FINAL
ENVIRONMENTAL IMPACT
STATEMENT

HAYDEN-BLUE RIVER
345 kV
TRANSMISSION LINE
PROJECT

JULY 1982

USDA-REA-EIS (ADM): 82-2-F
FINAL ENVIRONMENTAL IMPACT STATEMENT

FIGURE 2

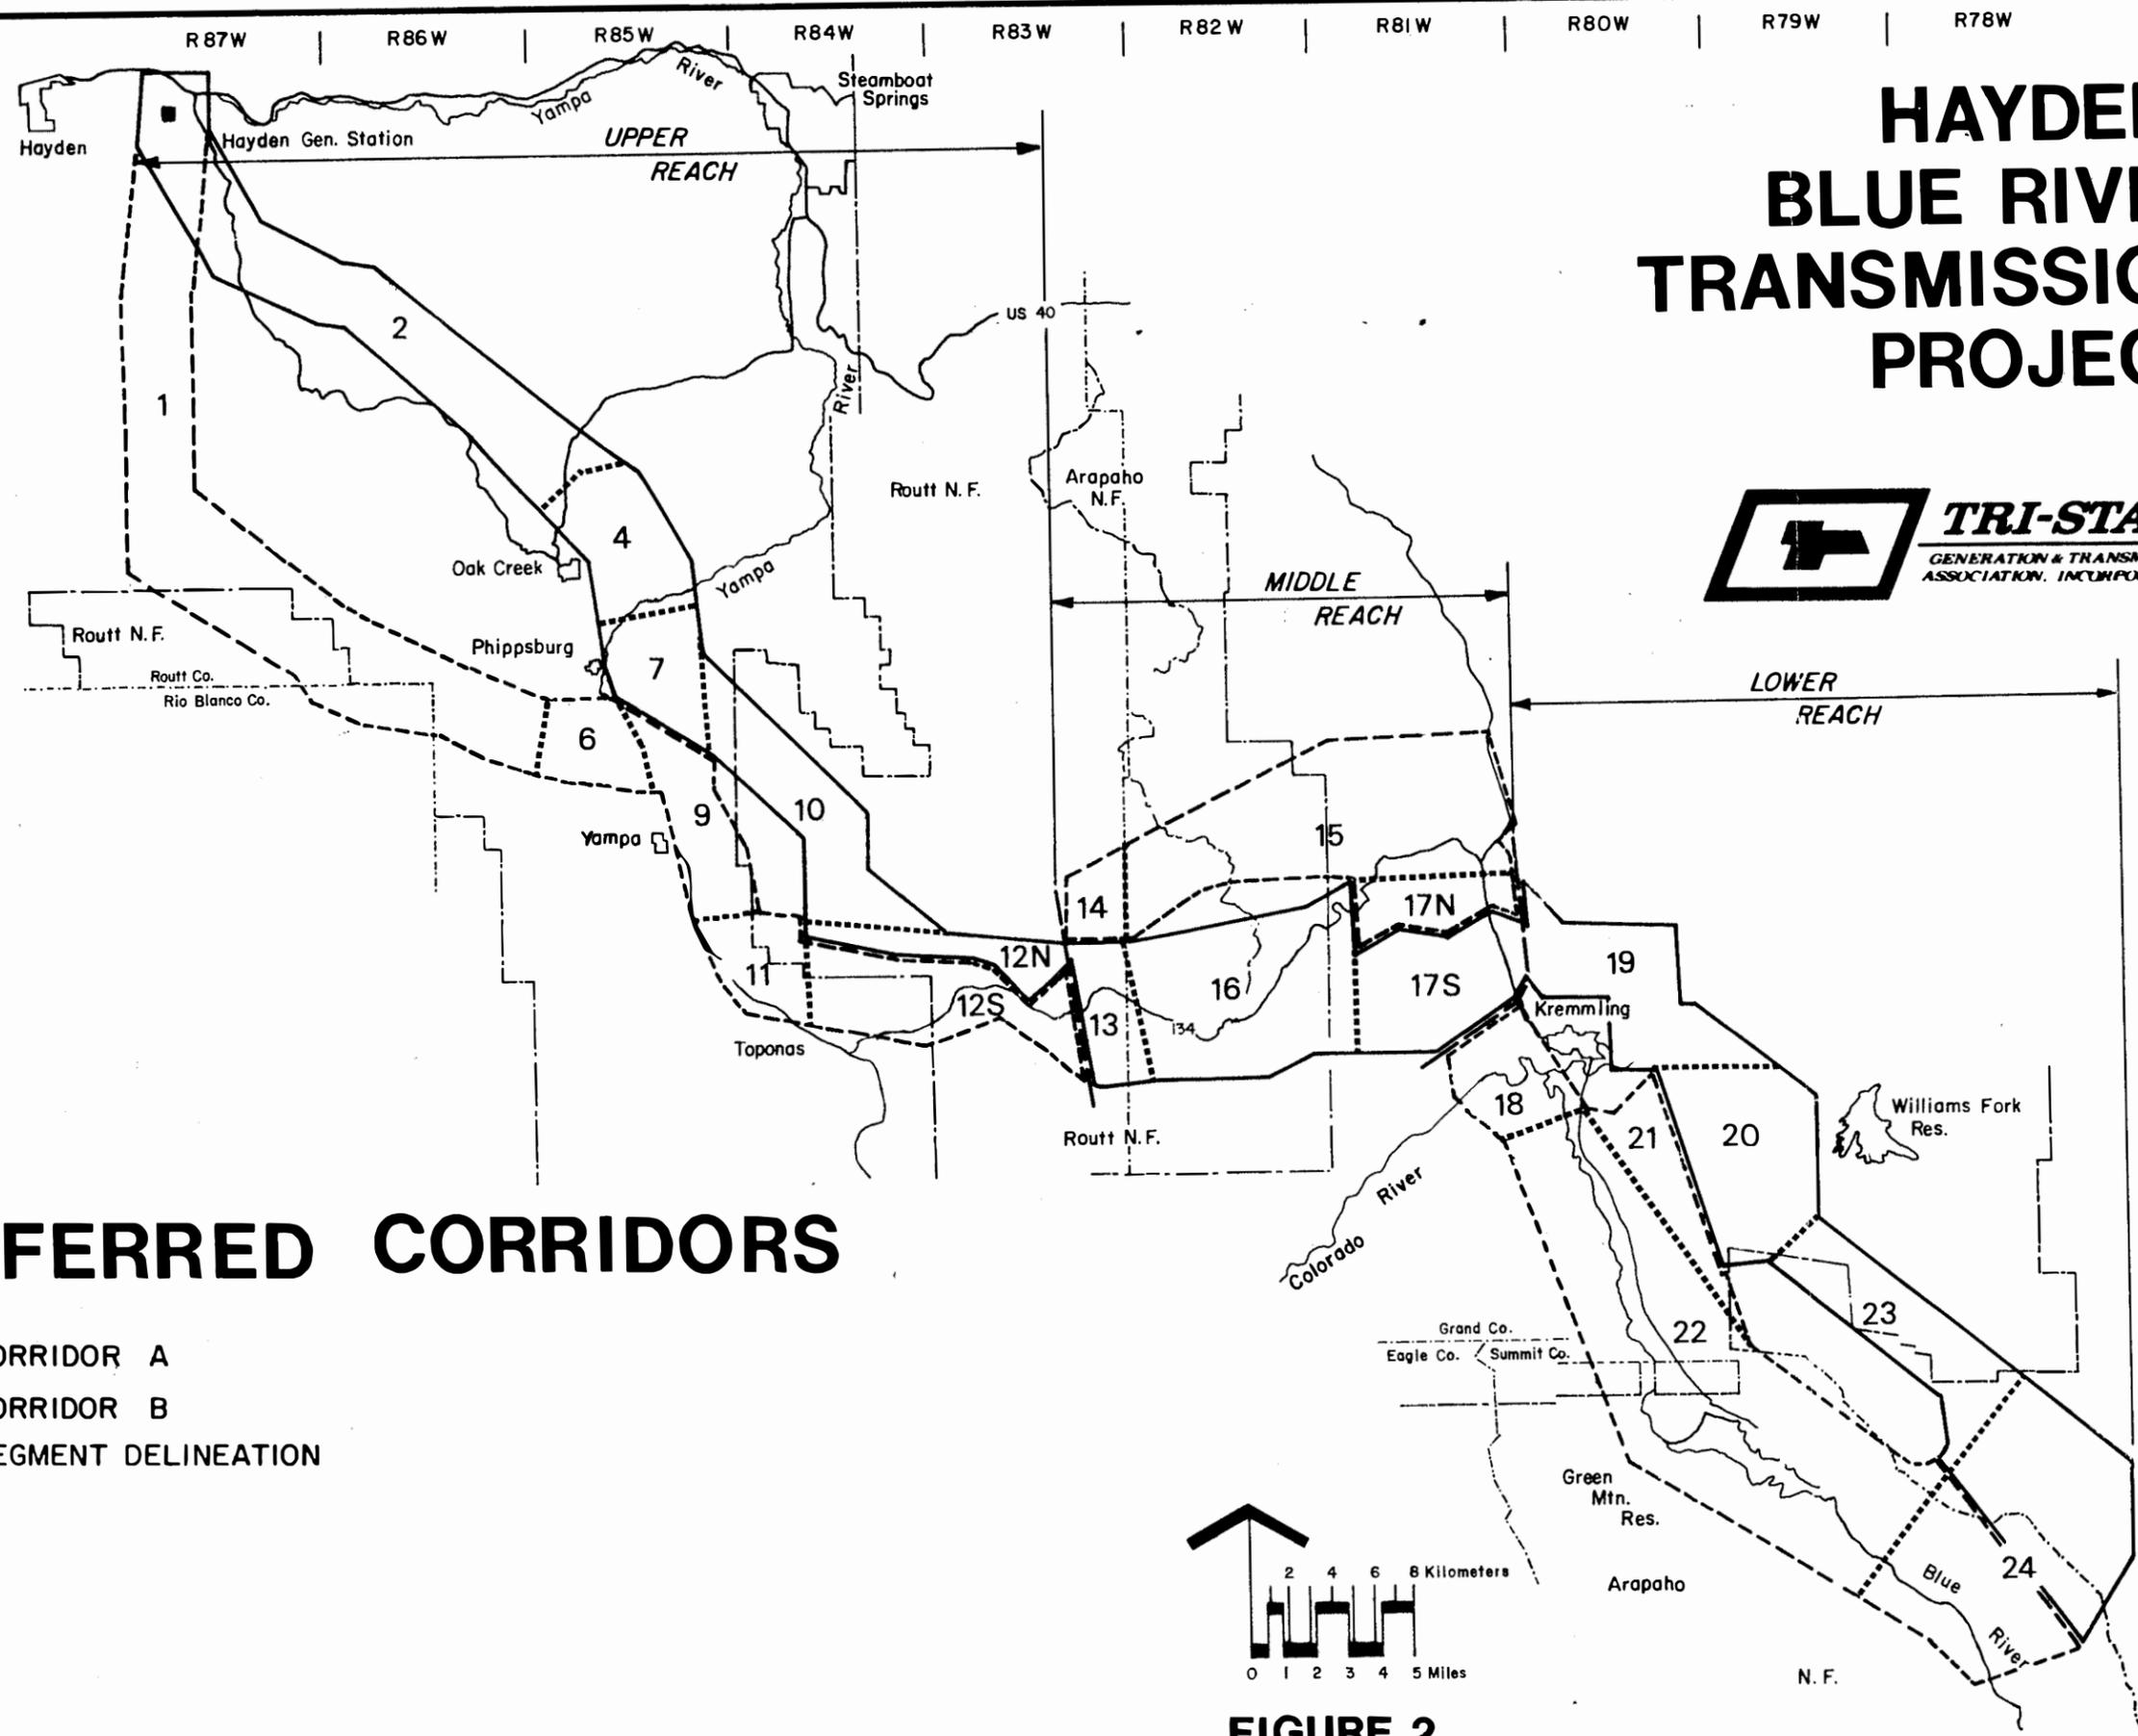
A number of commentors are concerned with proper discussion of how the alternatives relate to one another and how the corridors were selected. Tables 3 and 4 and Figure 2 are cited in answer to these questions and comments. Is the additional information added in these tables and figure adequate? Not really -- see Peter's comment

Your comment is noted. Refer to the responses to comments 1(b) and 3 of the Department of the Interior letter. The revised corridor alternatives discussion provides more detailed information with a new map (Figure 2) showing the corridor reaches and segments and data on the composite ranking of subcorridors as suggested. Contents of the referenced letter are included in Section 3.5.5.1.1 to clarify the corridor selection process. The section on corridor alternatives now contains discussion on the residual effects expected in each of the reaches of Corridors A and B (Section 3.5.5.1.2).
